# Proposed St. Paul's Residential Development, Raheny, Dublin 5

**Stage 1 Road Safety Audit (for Planning)**

- 1.1 Title** RSA ST PAULS S1
- 1.2 Audit Reference Number** RSA ST PAULS S1 KS 299
- 1.3 Project Code** STPAULS
- 1.4 Date Audit Completed** 26<sup>th</sup> August 2019
- 1.5 Audit Attended By** Ken Swaby  
Mark Andrews
- 1.6 Audit Team**
  - Team Leader** Ken Swaby, ILTP
  - Team Member** Mark Andrews, ILTP

**Figure 4.1: Pedestrian Crossing Facilities of Main Access road to Development not indicated in vicinity of Basement Access Junction and to West of Block 7**

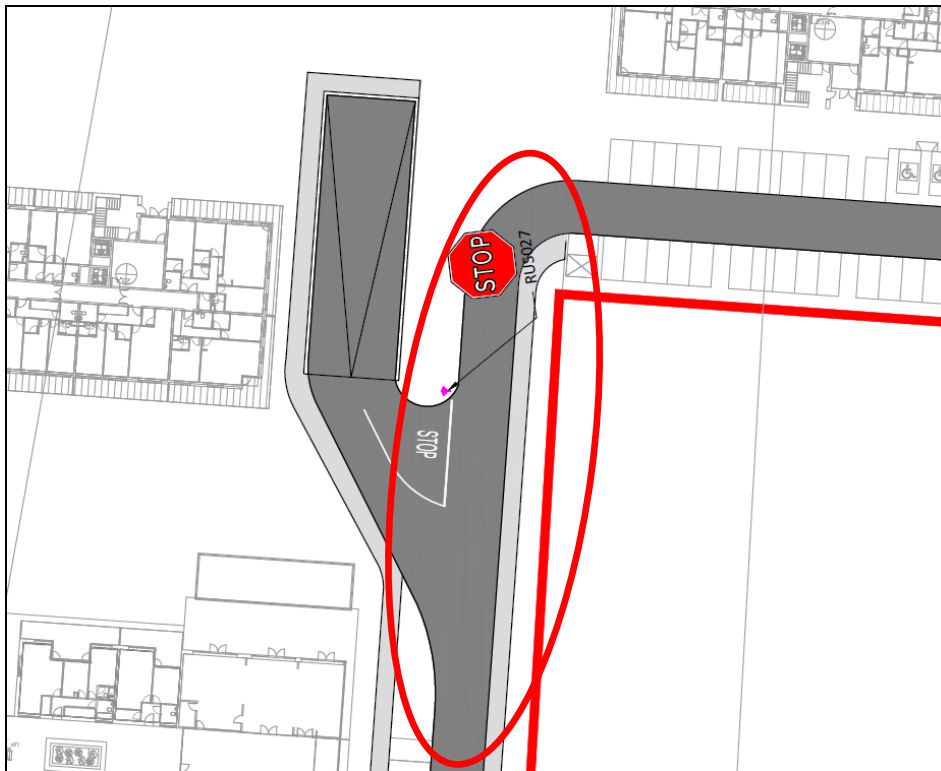
The information provided for audit does not indicate pedestrian crossing facilities of the main access road to the development in the vicinity of the basement access junction and to the west of Block 7 (refer to Figure 4.1). This area may be likely to have a number of pedestrian desire lines to and from the proposed development. Without appropriate pedestrian crossing facilities vulnerable road users may enter the carriageway in inappropriate locations, coming into conflict with other road users.

It is recommended that the design team ensures appropriate pedestrian crossing facilities are provided along pedestrian desire lines.

4.1.2	Y	Y	Uncontrolled Pedestrian crossing will be provided with appropriate tactile paving in the area in question. For crossing details refer to drawing N251-F02 attached.	Y See Note 1 below.

Client	Crekav Trading GP Limited.			
Project	St. Paul's Residential Development.			
Title	SWEEP PATH ANALYSIS RIGID VEHICLE			
Drn. By	Chkd. By	Apprd. By	Dep. No.	Revision
RB	MC	AH		
Date	Scale			
30/08/19	N.T.S. @ A1		N251 -C07	P1

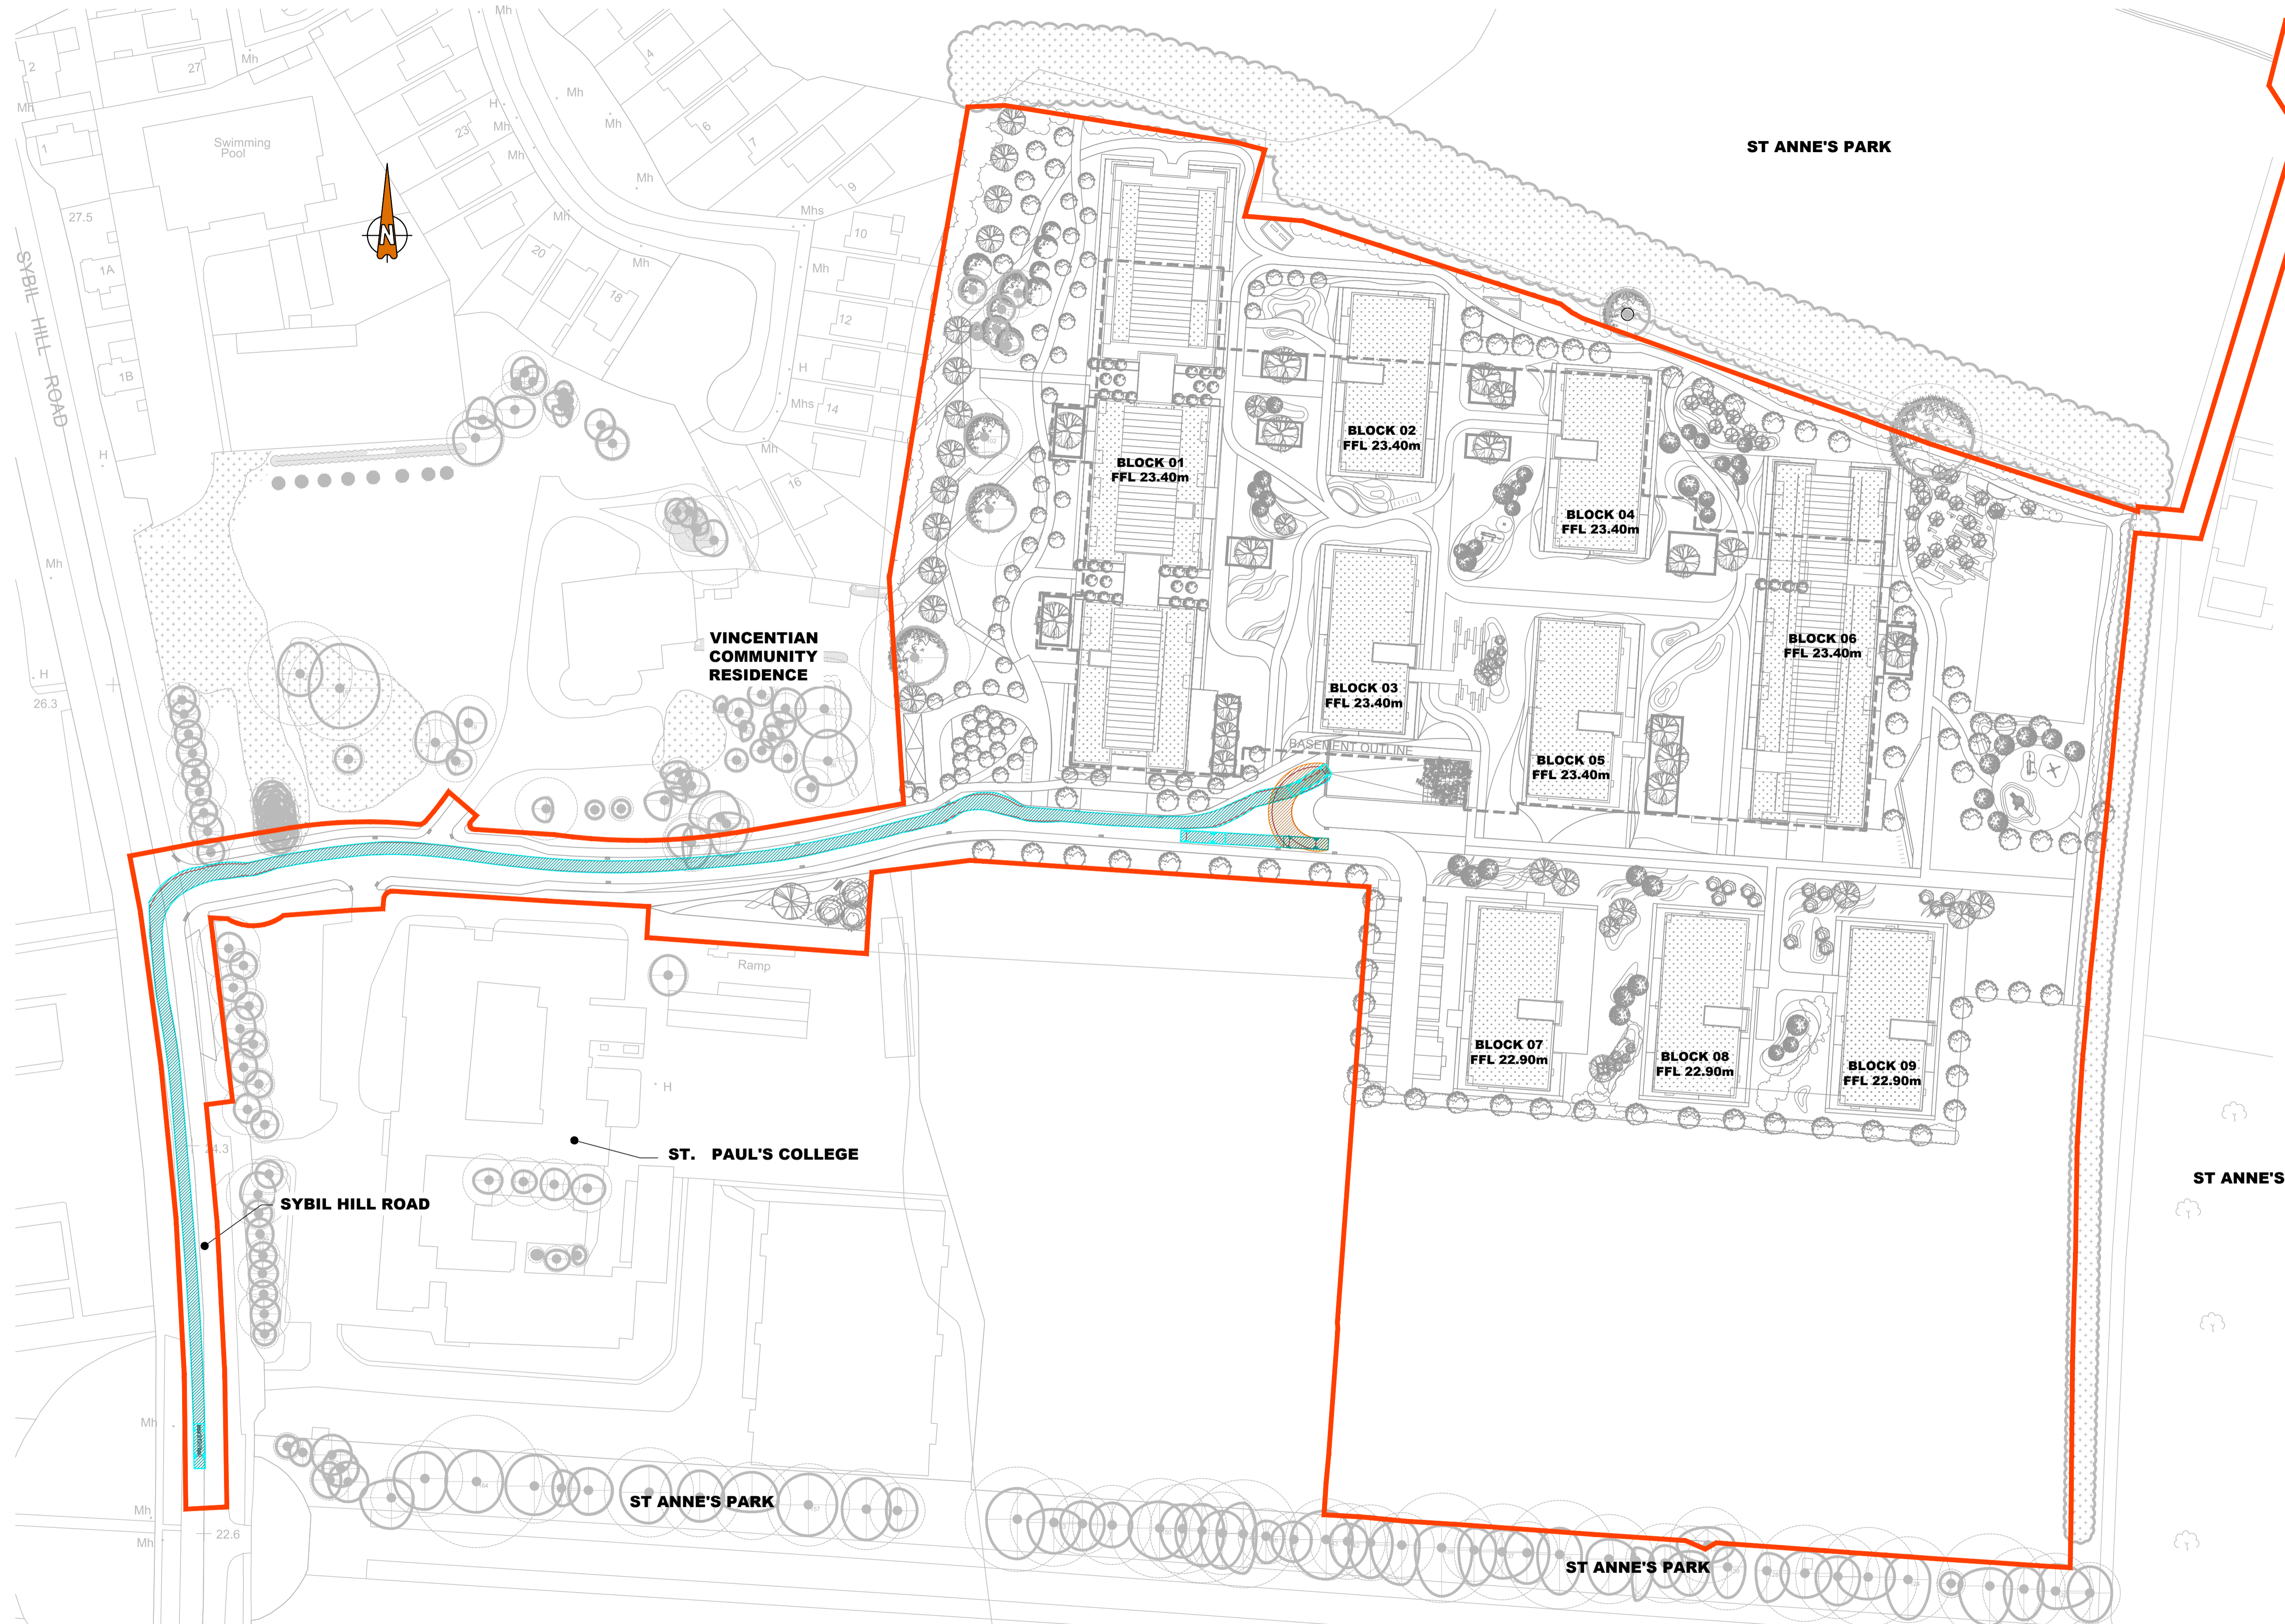
It is unclear from the information provided for audit if there is appropriate space for delivery, service and emergency vehicles to safely navigate the relevant areas of the site and perform turnabout manoeuvres within the confines of the carriageway or other designated areas. Inappropriate carriageway facilities present a potential risk of such vehicles coming into conflict with non-motorised users.

It is recommended that the design team ensures that the facilities provided are appropriate for all relevant vehicles to safely manoeuvre within the site.

4.1.3	Y	Y	Swept Path Analysis for Rigid Truck has been performed to ensure vehicles to navigate safely. For Rigid Truck Swept Path Analysis refer to drawing N251-C07 attached.	Y See Note 1 below.

Client	Crekav Trading GP Limited.			
Project	St. Paul's Residential Development.			
Title	VISIBILITY SPLAY			
Dn. By	Chkd. By	Apnd. By	Dep. No.	Revision
MC	JB	AH	N251 -C08	P1
Date	Scale			
23/08/19	N.T.S. @ A1

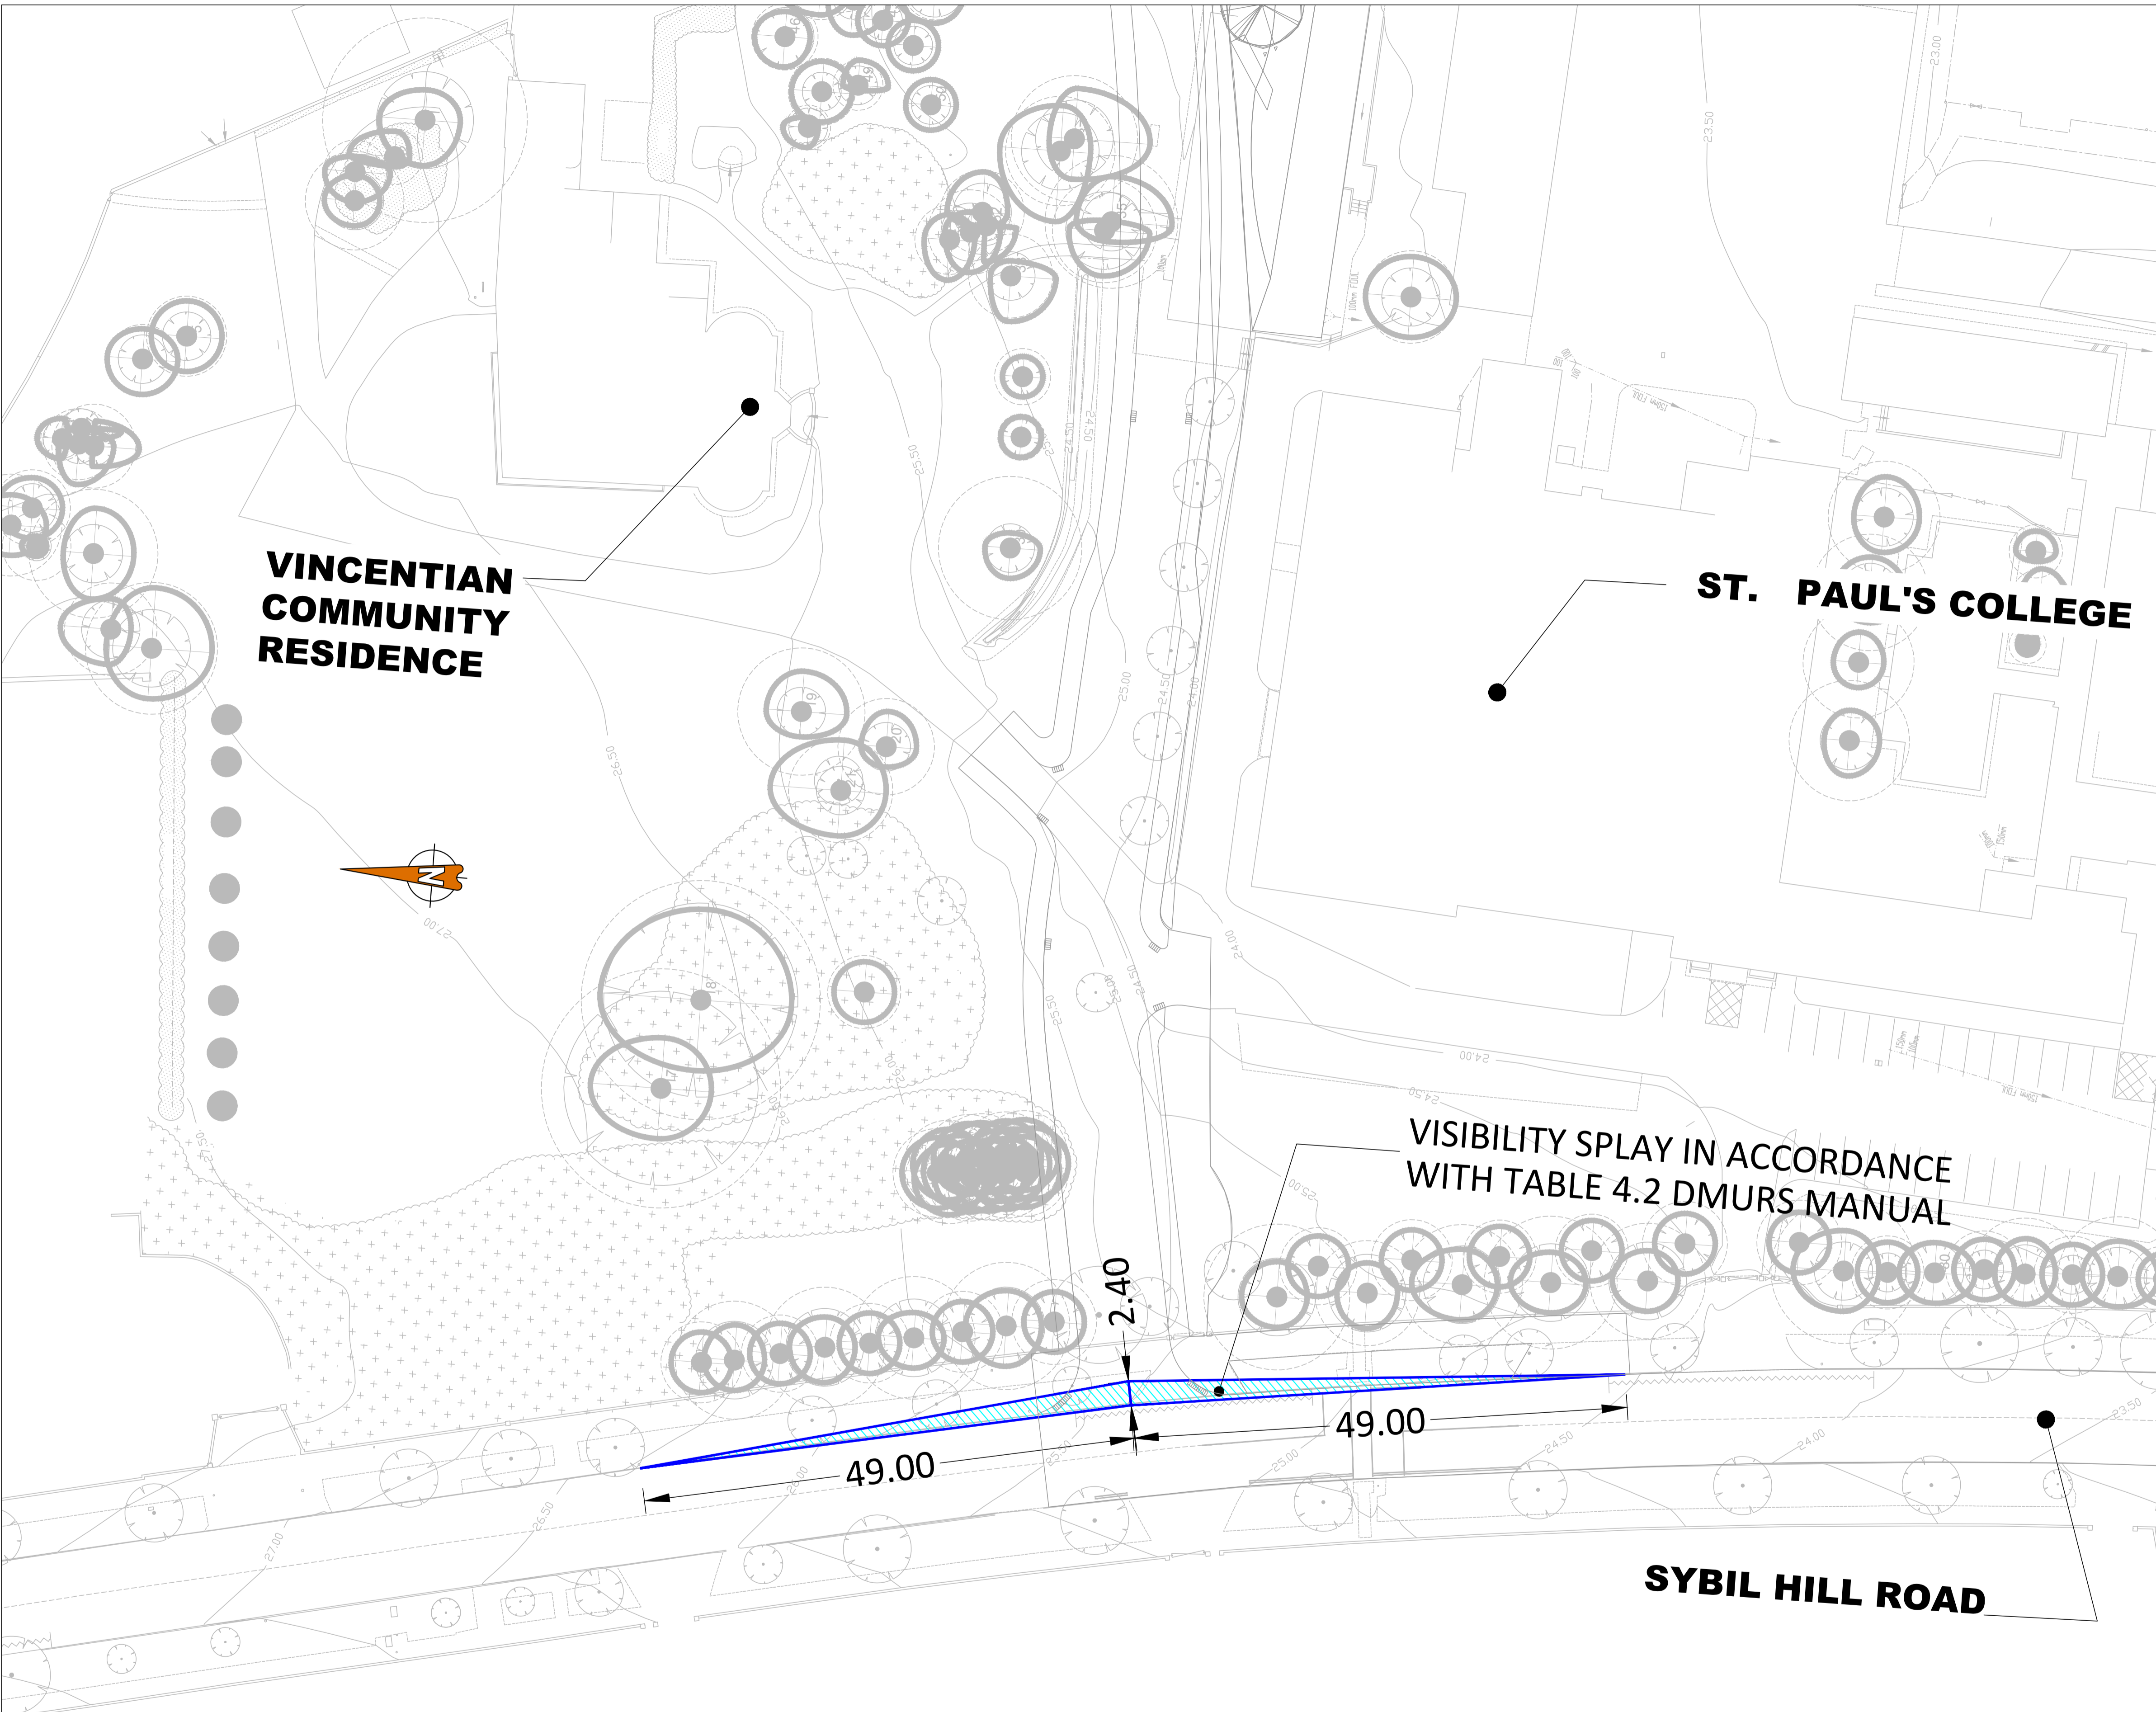
The site inspection has shown that there are a number of trees lining Sybil Hill Road immediately adjacent to the proposed vehicular access point. Should these trees encroach into visibility areas road users may emerge from the junction heedless of on-coming traffic resulting in side impacts, or approach the junction unaware of its presence and be forced to brake at the last minute resulting in shunt type collisions.

It is recommended that the design team ensures that adequate visibility can be attained both from and to the proposed access arrangements. Should appropriate visibility not be attainable from the proposed alignment it is recommended that the design team amends the layout of the junction or adjusts the nature of the vegetation.

4.1.1	Y	Y	The Visibility Splay analysis performed shows that existing trees lining Sybil Hill Road are not fully inside the visibility envelope. According to DMURS, objects that would not be large enough to wholly obscure a vehicle, pedestrian or cyclist may be acceptable providing their impact on the overall visibility is not significant. Refer to drawing N251-C8 attached.	Y See Note 1 below.
